Proposed Revisions to a Standard Plans Index

Index Number: 521-611

Sheet Number (s): 2 of 4

Index Title: Concrete Barrier/Junction Slab - Wall Coping (FRP)

TYPICAL SECTION THRU PRECAST 36" SINGLE-SLOPE
CONCRETE BARRIER AND COPING WITH C-I-P JUNCTION SLAB

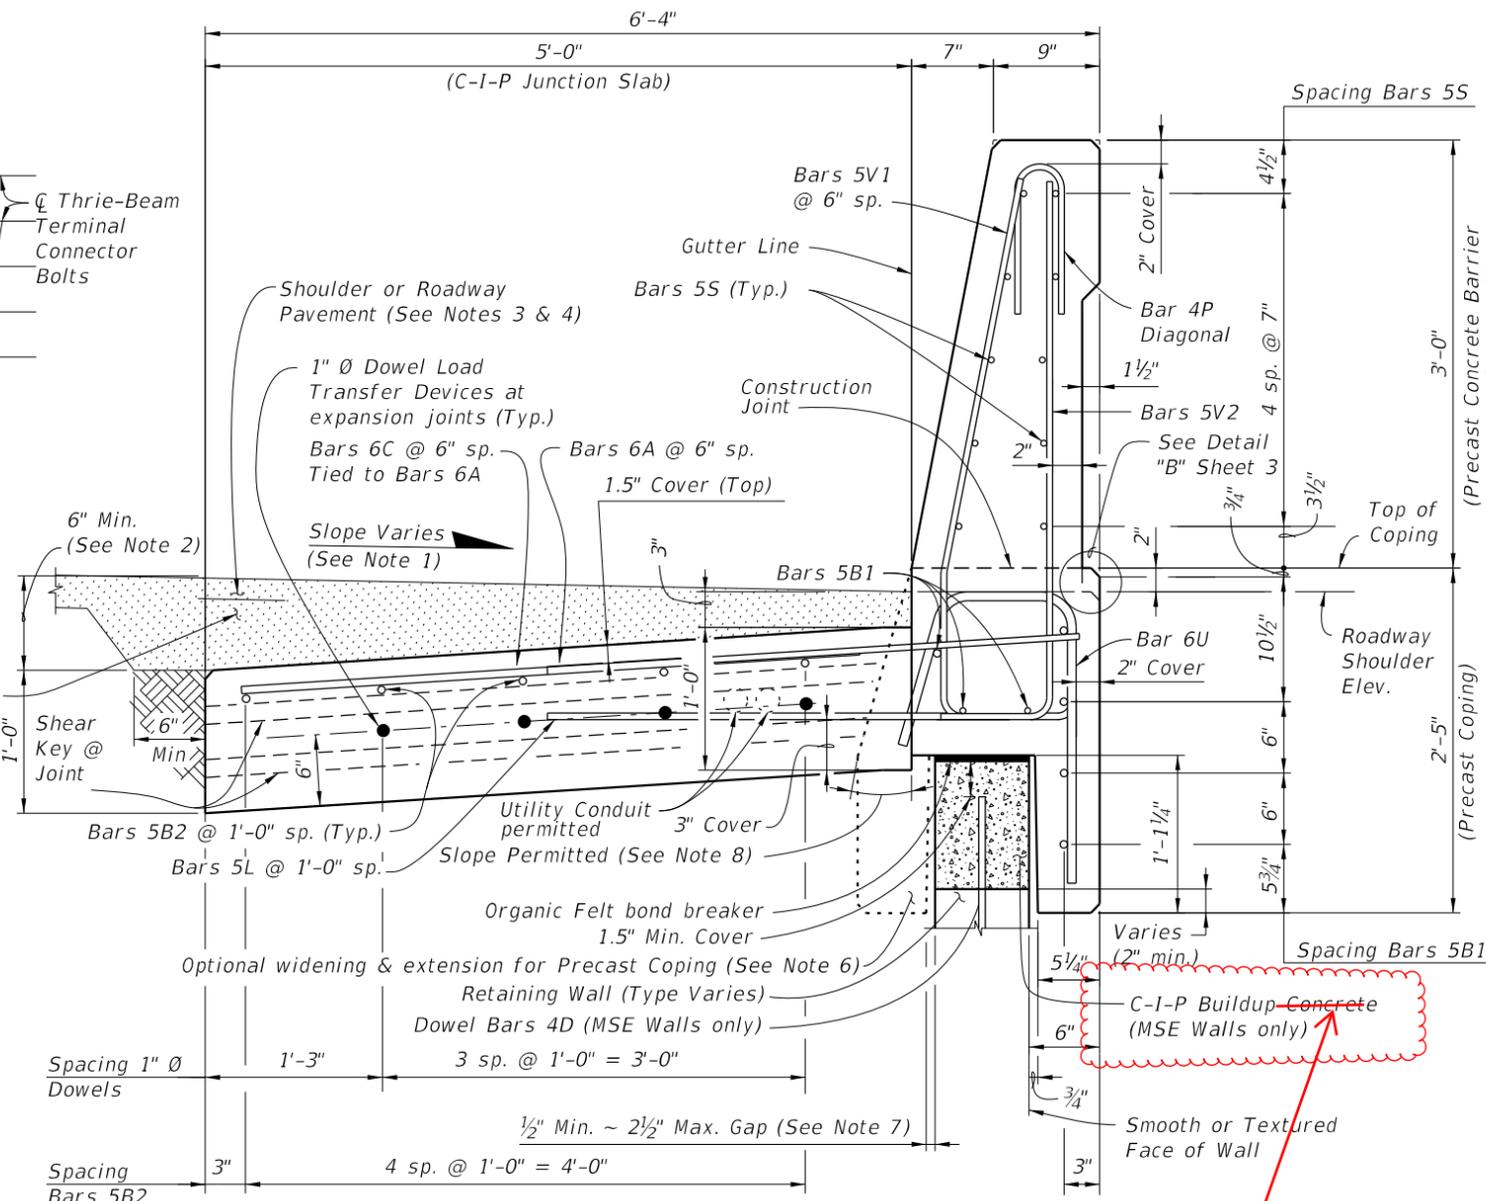
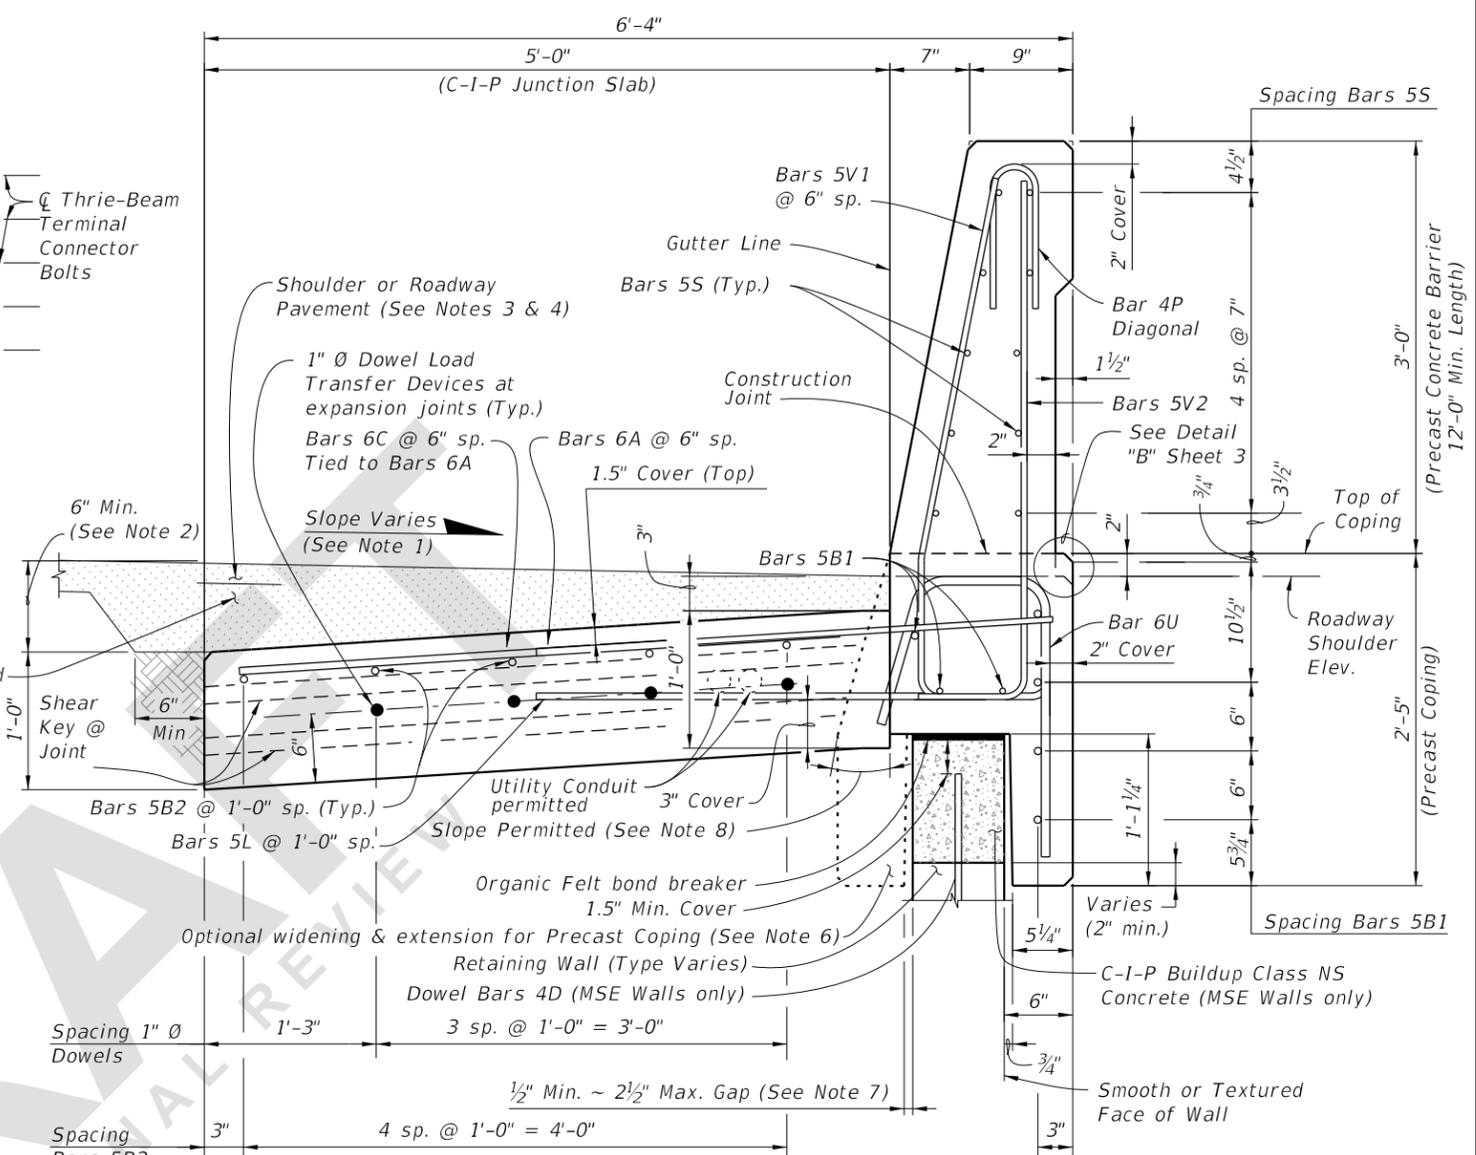
Changed C-I-P Buildup Concrete (1'-1" Max.) callout in the TYPICAL SECTION THRU PRECAST 36" SINGLE-SLOPE CONCRETE BARRIER AND COPING WITH C-I-P JUNCTION SLAB to C-I-P to Class NS Concrete (1'-1" Max.).

CHANGED TO: Class NS Concrete

CIP buildup concrete type was never clarified. SDO review deems Class NS is acceptable because the concrete buildup section is not meant to transfer any meaningful load to the wall other than self weight.
